DD+DIS178.16E

Service Bulletin

Increasing the lifetime of Power LED on RALCO Collimators and avoiding stripes in Collimator light

Figure 3

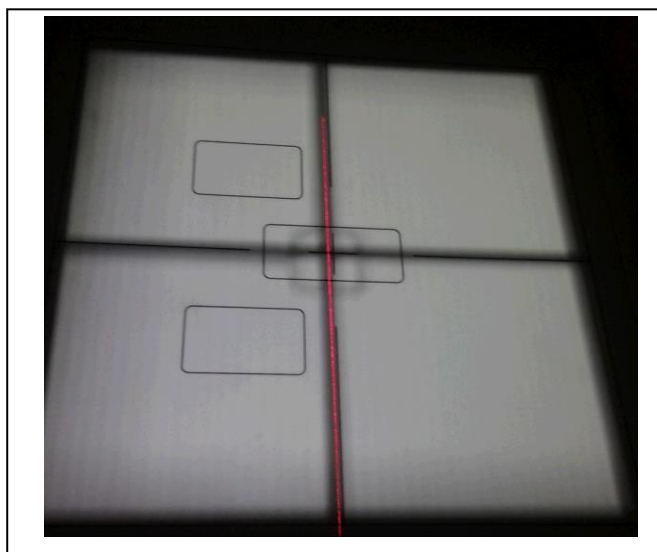
Symptom Collimator light shows shadow / black stripes that look like moiré stripes on FLFS images.

Cause Power LED current settings needs to be adjusted after replacement of the Power LED.

Solution Adjust the LED current to approximately 3.4 A (+/- 5%). For details refer to section 3.2.

Figure 4: Power LED (Example)

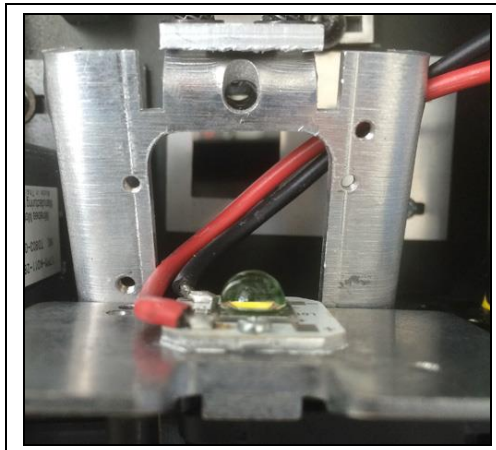
Make sure that the cables do not cover the LED light and that they are routed in a way that the LED light can freely enter the collimator.

Figure 5: GC-LED 5A PCB (Timer PCB), new version

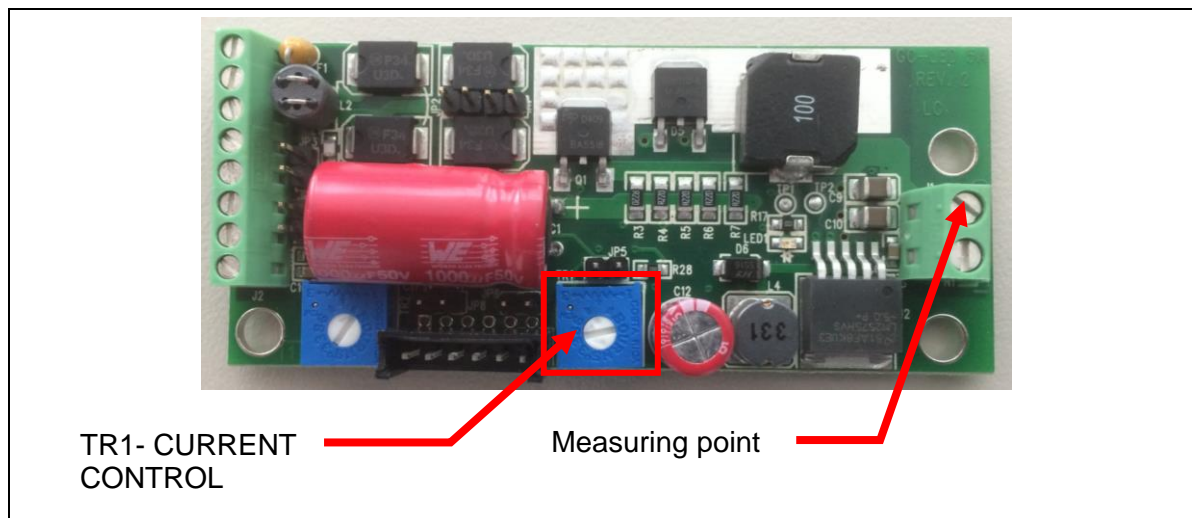
- (1) Adjust the output current intensity to the LED to approximately 3.4 A (+/- 5%) with the TR1- CURRENT CONTROL potentiometer (see Figure 5).
